April 26, 2005

**Safety Recall Notice #05V-149**

## Primary Drive Sprocket Nut Inspection and Installation Instructions Recall #05V-149

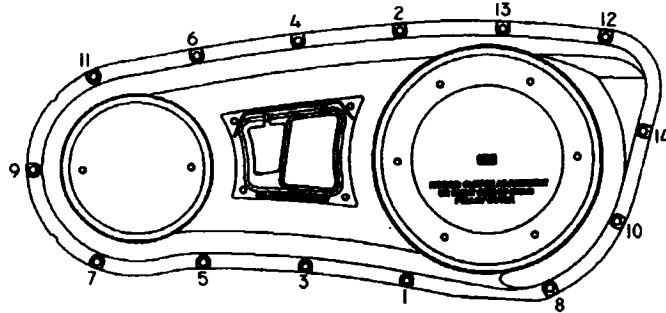
1. Remove the outer primary cover.
2. Inspect the sprocket nut.
  - a. If the sprocket nut is 7/8"-14 X 3/4" move to step 5 (Reassemble the primary drive).
  - b. If the sprocket nut is 7/8"-14 X 1/2" remove and replace with the correct 3/4" nut.
  - c. If the incorrect sprocket nut (1/2") has backed off, inspect for sprocket, rotor and/or sprocket shaft damage.
  - d. If damage is extensive to the sprocket shaft and cannot be repaired, contact Technical Support.
3. Clean the sprocket shaft threads thoroughly of Loctite and debris.
4. Install 7/8"-14 X 3/4" primary drive sprocket nut on the sprocket shaft and verify that the nut runs on and off freely.

5. Reassemble the primary drive:
  - a. Install the 7/8"-14 X 3/4" primary drive sprocket nut P/N: BDM120-00597 with applied torque of 150 ft-lbs and 3 drops of Red Loctite 262 to the sprocket shaft threads.
  - b. Insert a 8" X 1" X 1/4" BDM primary locking bar (or equivalent) between the drive sprocket and clutch ring gear and torque the nut to 150 ft-lb.
  - c. Adjust the primary drive chain to 5/8" deflection.
  - d. Torque the adjuster to 25 ft-lbs.
6. Install outer primary cover making certain the O-ring and mating surfaces are clean with O-ring seated in the grooves.
7. Follow the outer primary torque sequence. 90-110 in-lbs 1 Drop – Purple Loctite 222.
8. Clean and reinstall magnetic drain plug. Torque to 90-110 in-lbs.
9. Fill with 48 oz. of primary fluid.
